Revised

FORD LUMBER SUBDIVISION

APPLICATION NUMBER Holdover DATE March 16, 2006

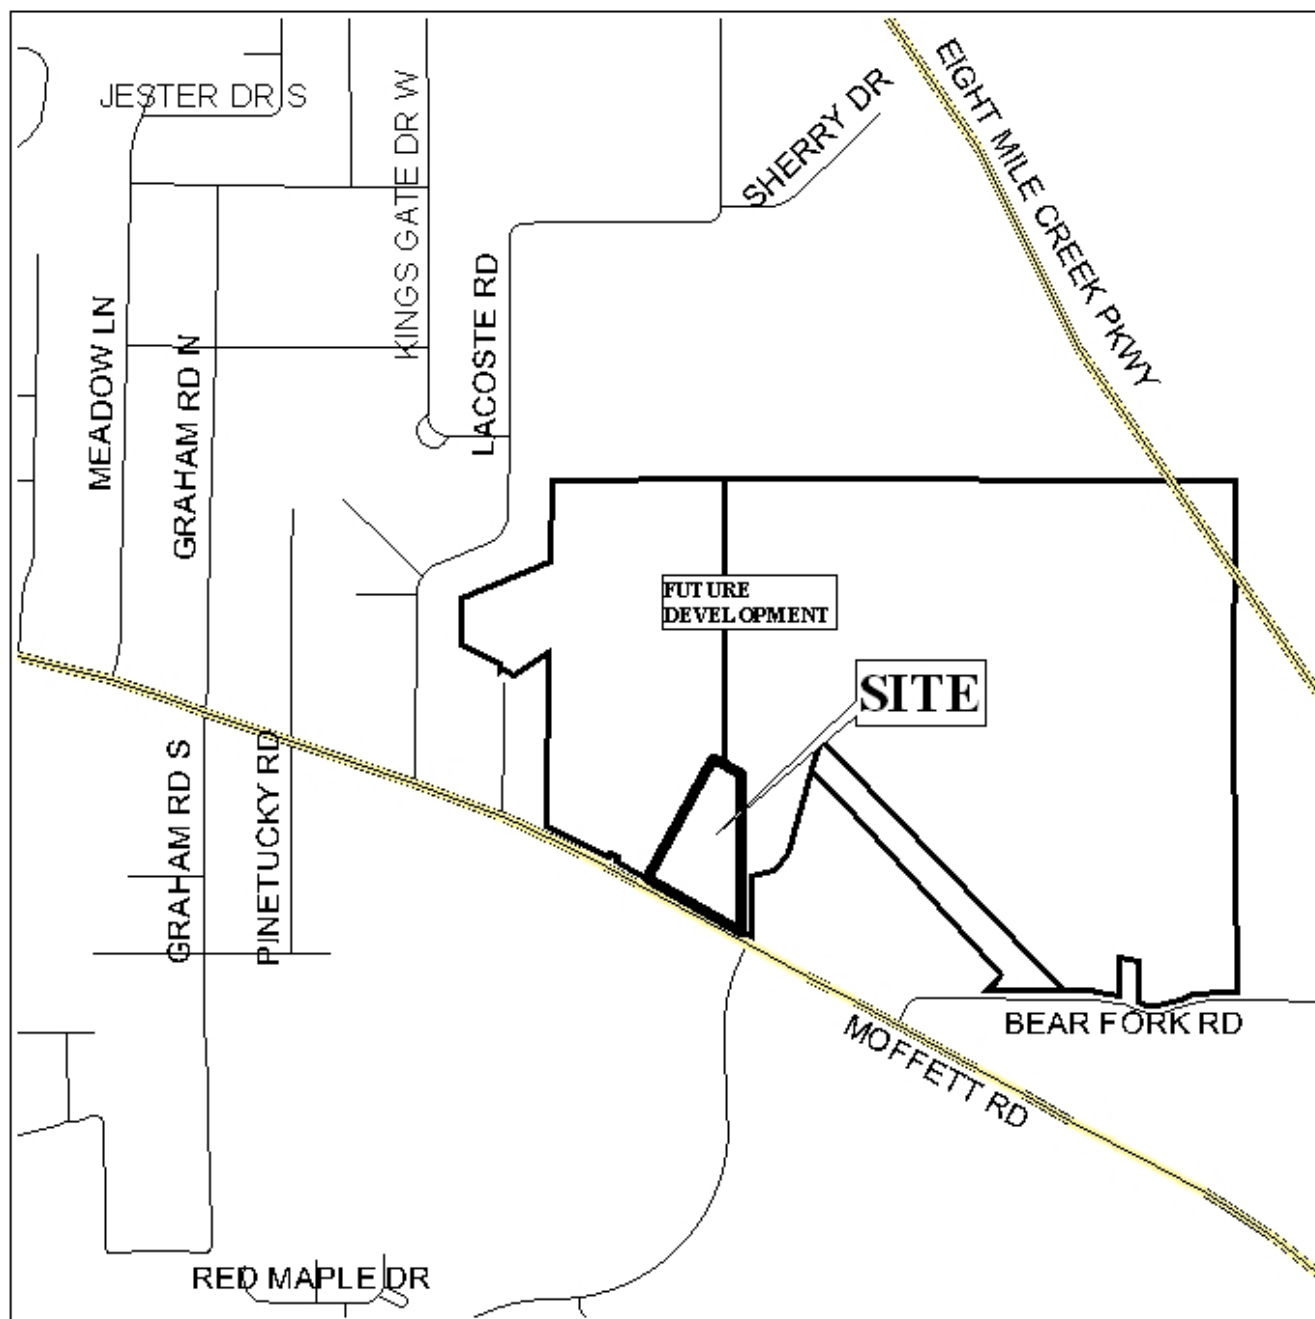
The original unapproved division of the subject property from its parent parcels has created some issues with the configuration of the property. First, proposed Lot 3 is oddly shaped, having 253 feet of frontage on Moffett Road, narrowing to 55 feet at its center, and immediately widening to approximately 365 feet north of the “waist”. Should this configuration be approved, a note should be required on the final plat stating that no further resubdivision of Lot 3 is allowed until such time that the rear portion of the property has frontage on a public street.

It should also be noted on the final plat that the future development parcels may not be developed until they are legally subdivided.

Regarding the proposed three-lot subdivision, the site should be limited to a single curb cut for each lot, as a means of access management.

The plat meets the minimum requirements of the Subdivision Regulations, and is recommended for Tentative Approval, subject to the following conditions: 1) dedication of sufficient right-of-way to provide 50 feet from the centerline of Highway 98; 2) depiction of the 25-foot building setback lines on the final plat, measured from the dedication; 3) the placement of a note on the final plat stating that any lots that are developed commercially and adjoin residentially developed property must provide a buffer, in compliance with Section V.A.7 of the Subdivision Regulations; 4) the placement of a note on the final plat stating that future development parcels cannot be developed until legally subdivided; 5) the placement of a note on the final plat stating that no further resubdivision of Lot 3 is allowed until such time that the rear portion of the property has frontage on a public street; and 6) the placement of a note on the final plat stating that the site is limited to a single curb cut for each lot.
